Amending Plat of Bridgepointe Landing, Block 1, Lot 5R and 6R

Planning Commission Presentation
August 22, 2018

Bridgepointe Landing, Block 1, Lot 5R and Lot 6R: May 2018

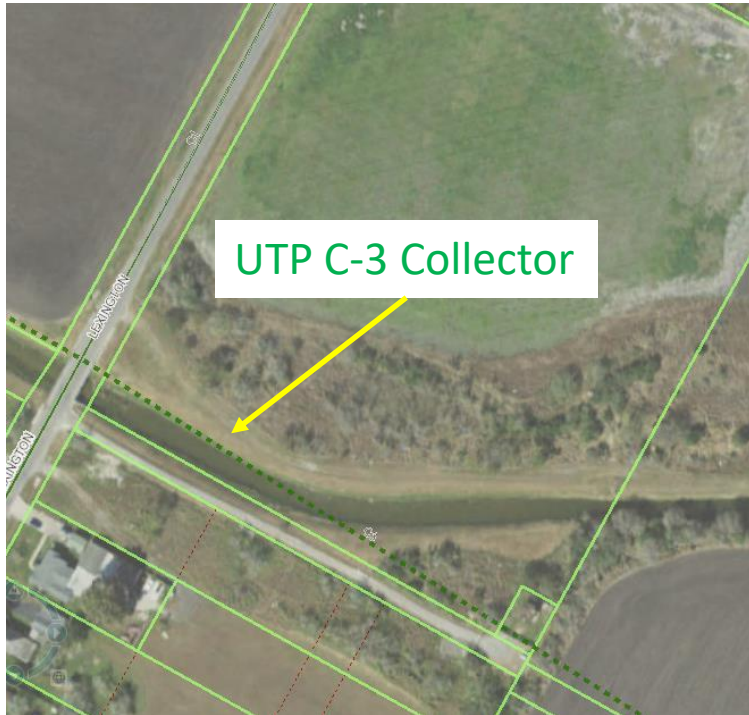
- City's position: new infrastructure required
 - **Texas Loc. Gov't Code §212.016(11):** "... to replat one or more lots fronting on an existing street if:

- (C) the amendment does not increase the number of lots; and
 - (D) the amendment does not create or **require** the creation of a **new street** or make necessary the extension of municipal facilities.

New Street Requirement: Williams Drive

Williams Drive: C-3 Collector

ROW Width: 75 feet

Pavement Width: 50 feet

Date	Event
1996	Preliminary Plats approved by Planning Commission in March and December show --Williams Drive alignment shown on the property, and street sections. --104-foot drainage right-of-way
2004	Preliminary Plat approved by Planning Commission shows --Williams Drive shown on the property, and street sections, and --180 to 200-foot drainage right-of-way, and a bridge over drainage easement.
05/12/2010	Preliminary Plat and Final Plat Lot 6, Block 1 approved by Planning Commission. --Williams Drive is no longer shown on the Preliminary Plat. --50-foot drainage right-of-way is shown.
2010 - 2013	Six Time Extensions of Final Plat and Two Extensions of the Preliminary Plat.
02/18/2014	Williams Drive alignment is moved back onto the subject property by UTP amendment and Ordinance 030091.
05/22/2014	Final Plat Lot 6, Block 1, is recorded. Preliminary Plat of Lot 6, Block 1 <u>expired.</u>
05/22/2018	Applicant submits plat application for "replat" of Lots 5 and 6, to "adjust a common lot line." The applicant changes the submittal to an "amending" plat. Williams Drive dedication and construction is required per UTP and Ordinance 030091 (02/18/2014).

Does not satisfy the review criteria:

- ☒ Does not meet requirements of code and state law
- ☒ Inconsistent with Comp Plan, Utility Master Plans, other adopted plans relating to **future streets**, and extension/improvement of roads, water, stormwater
- ☒ Plat does not meet subdivision design and improvement standards to promote health, safety or general welfare

Staff recommends denial of the
Amending Plat
